## DESIGN REVIEW COMMISSION AGENDA

Request: Design Review approval of a 57-unit townhome project with fourteen (14) buildings known as the Lacrosse Avenue Townhomes on five (5) combined parcels totaling four (4) acres. (DR-1-25)

**DECISION POINT:** Should the Design Review Commission approve the design for a proposed 57-unit townhome project with 14 buildings with or without conditions, or direct modifications to the project's design and require a second meeting?

#### *D. Treatment of Blank Walls*

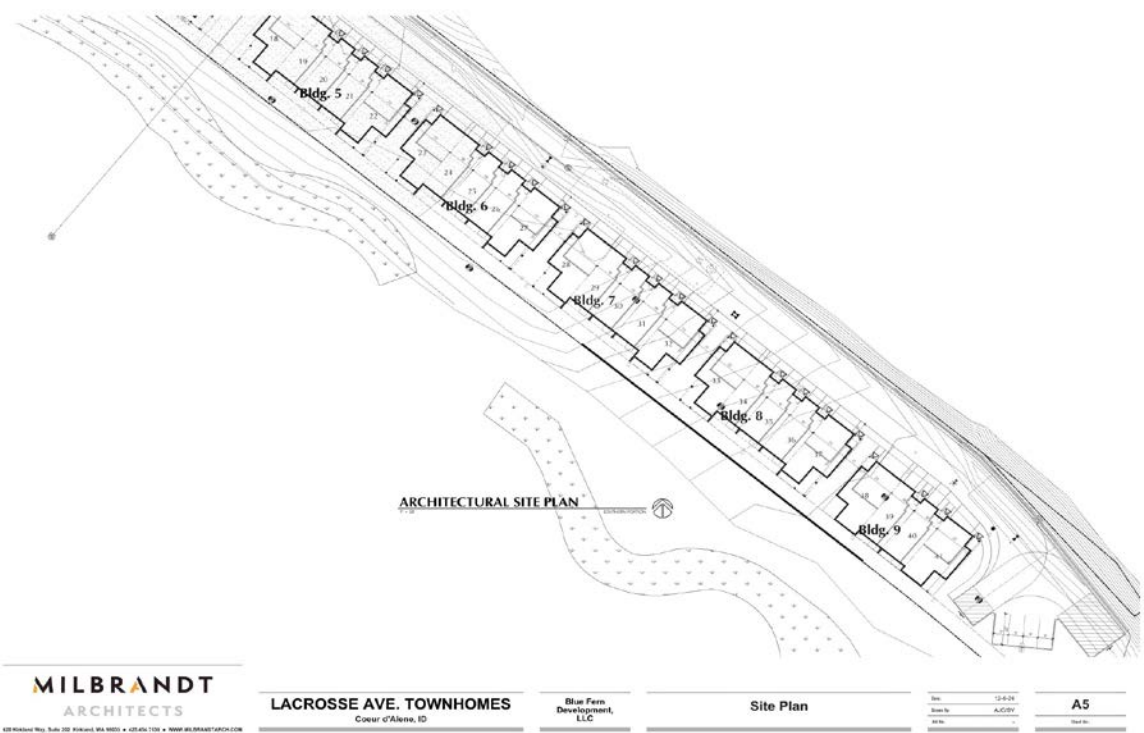
1. Any wall that faces a street shall incorporate at least three of the following features: An architectural plinth (a stone or masonry base at least 36” high), Belt course(s) of masonry, Trellis with vines planted that will grow vertically, Recesses at least 4 feet wide and 2 feet deep, Overhanging roof, Decorative tile

a. *The front facades of Buildings 12-14 face W. LaCrosse Ave. These elevations are designed and detailed without blank walls, as windows, entrances and modulation are provided at each individual unit. In addition, front porch recesses exceeding 4' wide and 2' in depth, overhanging low porch roofs, and accent lighting are provided at these building facades.*
